## Cumnor Parish Council - Plan Receiver - [P24/V2480/FUL](#)

<b>Date Reviewed:</b>	10/12/2024
<b>Version:</b>	V1
<b>Application Reference:</b>	<a href="#">P24/V2480/FUL</a>
<b>Application Type:</b>	Full
<b>Proposal:</b>	Subdivision of land to rear and erection of 5 bedroom 2.5 storey dwelling with rooms in the roof space and 1.5 storey detached garage. Use of new access to Cumnor Hill allowed by application P23/V1945/HH. Provision of fire appliance turning space, associated landscaping and bin store.
<b>Address:</b>	96 Cumnor Hill Oxford OX2 9HY

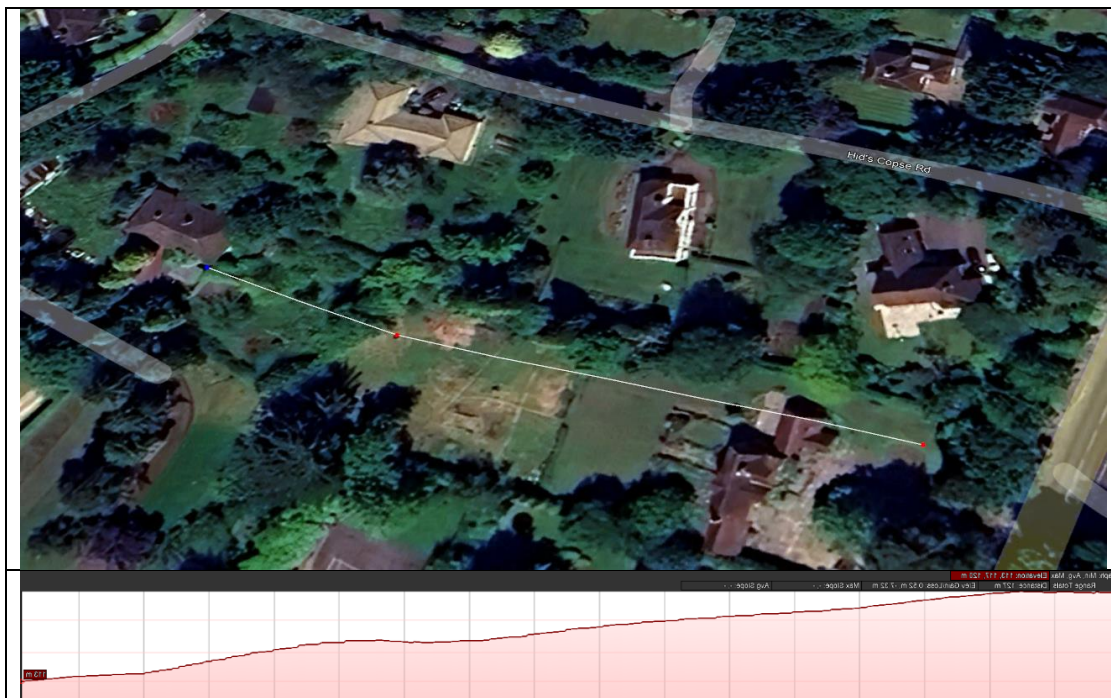
- Although no TPOs for the site can be found, many trees shown in the plans for [P23/V1945/HH](#) are now absent in the proposed plans for this application ([P24/V2480/FUL](#)) and on the intermediate [P24/V0162/HH](#) and [P24/V1523/LDP](#) applications (see below).

For example, four 10m high trees at the SSW end of the garden retaining wall, and on the line of the proposed access drive to the backland development, are visible on the [P23/V1945/HH](#) plans (above). They are absent in the plans for this application – and in the plans for the intermediate applications.
